Your reference: DM115/2/23
Our reference: Response to RFI for DM ZP3439RM

Thank-you for your letter, reference: DM115/2/23 dated 16th February 2023, which requested further information regarding the Environmental Permit variation application for the Knowsley Waste Facility, EPR/ZP3439RM/V004.

Mulberry Waste Limited, Knowsley Waste Facility, Application reference: EPR/ZP3439RM/V004

Expanded Process Flow Diagram

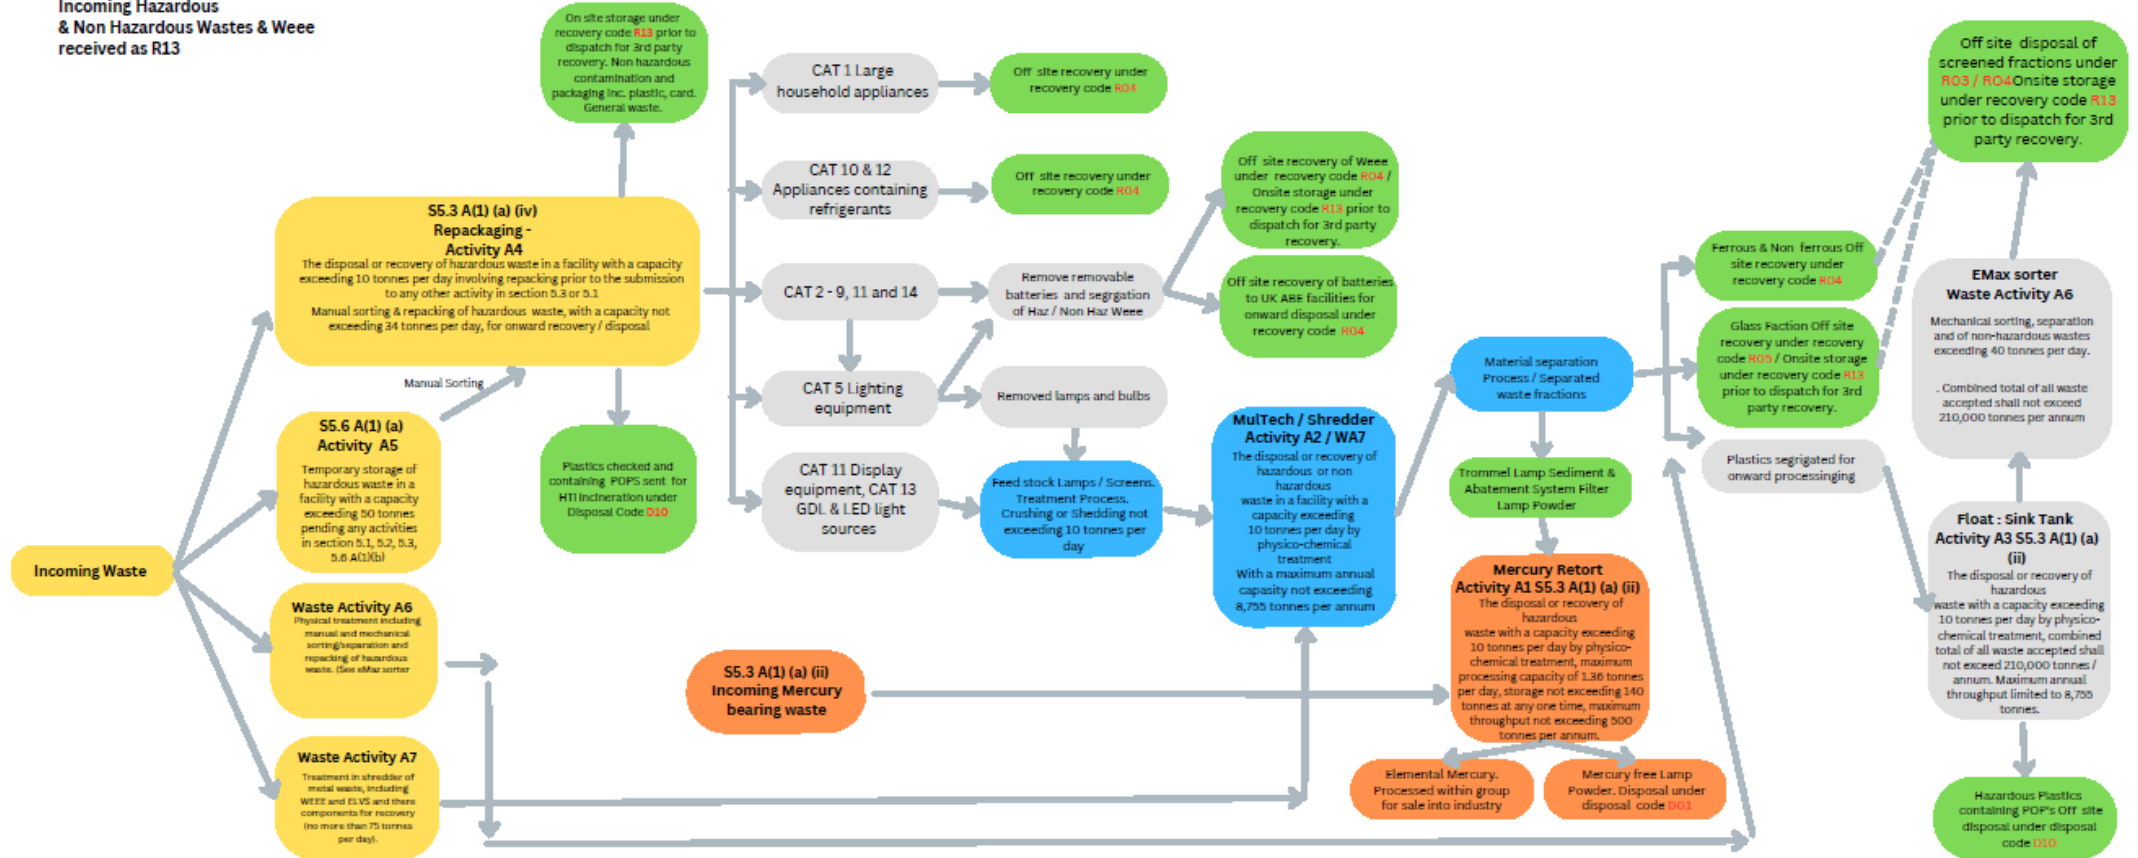
2) You have requested that we provide a process flow / block diagram for the regulated facility which includes the proposed changes. You have requested that this is labelled with any relevant Scheduled Activity reference and capacity.

However, since the original submission, an alteration to the proposal has been identified, which contributes to our response to your third question (below).

The original planned activities at the site, detailed in our original submission, assumed that hazardous and non-hazardous wastes would be sorted in the eMax (activity references A3 and A6). However, it has now been confirmed that the incorporation of a float : sink tank between the Multec and the eMax will remove the hazardous fraction of the materials from the eMax feedstock. Therefore, the eMax will not receive hazardous waste and will only be required to treat non-hazardous wastes (activity reference A6). However, the incorporation of a float : sink tank as an integral part of the Multec / eMax operation, with a potential processing capacity of more than 10 tonnes mixed (including hazardous) waste per day is a new scheduled activity (S5.3 A(1) (a) (ii)) and can now become activity reference A3. I note however that, irrespective of the fact that this additional process step is reasonably associated with the Multec (activity reference A2 which is already subject to a substantial variation), it also carries the same application activity description of that, and now the retort (S5.3 A(1) (a) (ii)) and therefore, the cost of including this float : sink tank process into the application reduces all but the highest charge for the same activity descriptions by 90 % (see extract from The Environment Agency (Environmental Permitting and Abstraction Licensing) (England) Charging Scheme 2022. Version 1.1 in Appendix 1). This is discussed in greater detail in response to your fifth question (below).

We have therefore revised and expanded our process flow / block diagram, and this is now presented over page.

A description of the float : sink tank and its operation follows:

The specific gravity of water is 1,000 kg m⁻³ and as such, polypropylene (PP) and polyethylene (HDPE and LDPE) which have lower densities will float in water. Other contaminants such as glass, grit and dirt will sink because of their denser structure.

Although no specific manufacturer has yet been confirmed for the provision of the float : sink tank to be installed at the Knowsley Waste facility, such processes are typically fed by a belt conveyor, screw auger or blower. Depending on the application the material can be discharged onto the surface of the tank, or fed by a screw feeder submerged into the tank, which helps to give a uniform flow into the tank, breaking up any lumps, and ensuring that all materials are fully submerged at the start of the process. This produces a high purity product as all particles are forced to either float or sink.

The floating fraction is driven along the surface of the float sink tank by a series of rotating paddles. Each paddle completely submerges the floating fraction as it is pushed along the surface of the float sink tank. The speed of the rotating paddles can be changed to vary the agitation and the discharge rate. The floating fraction is transferred into an incline discharge screw via a weir at the end of the float sink tank and is removed for further processing through the eMax system. The sunken fraction collects at the base of the tank and is similarly transferred into an incline discharge screw, and is deposited into a collection container for storage prior to removal from site for disposal.

Monitoring, both during the commissioning phase of the process and then quarterly once operational will confirm that the floating materials comprise PP, HDPE and LDPE and do not contain any persistent organic pollutants (POPs). This material will then pass onto the eMax process for further screening and sorting. The collected sunken fraction is assumed to be hazardous and to contain POPs and will be sent for high temperature incineration for disposal.

Float : sink tanks capture, filter and re-circulate the water that might otherwise be lost when extracting the separated waste fractions, thereby minimising the top-up requirements of the tank.
